ADDENDUM NO. 4

November 25, 2025

THE NEW WALLACE AYLESWORTH MIDDLE SCHOOL
5910 Central Ave.
Portage, IN 46368

TO: ALL BIDDERS OF RECORD

STAGE LIGHTING PLAN

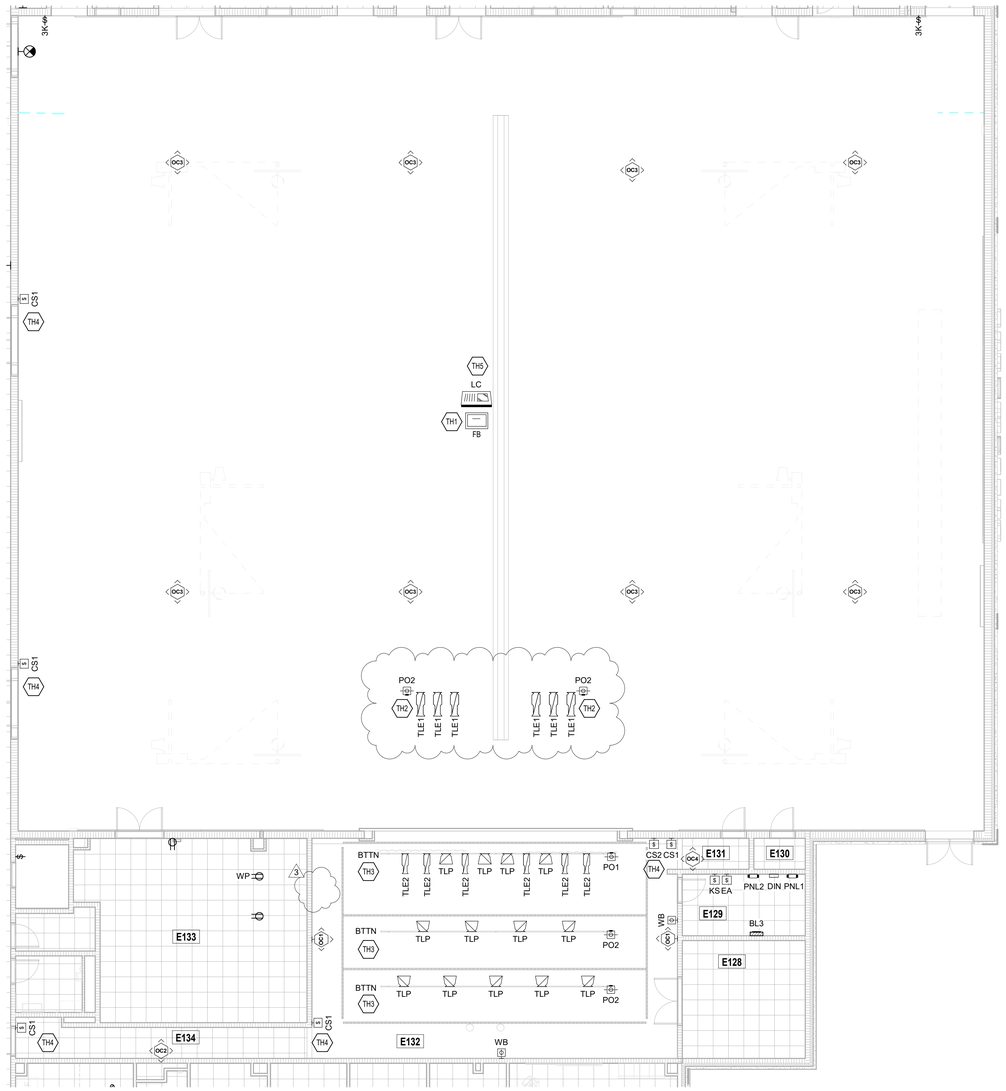
ITEM NO. 9. NEW DRAWING SHEET

A. Drawing Sheet No: E-702 – Stage Lighting One-Line Diagram dated 11/24/25, is included with and hereby made a part of this Addendum.
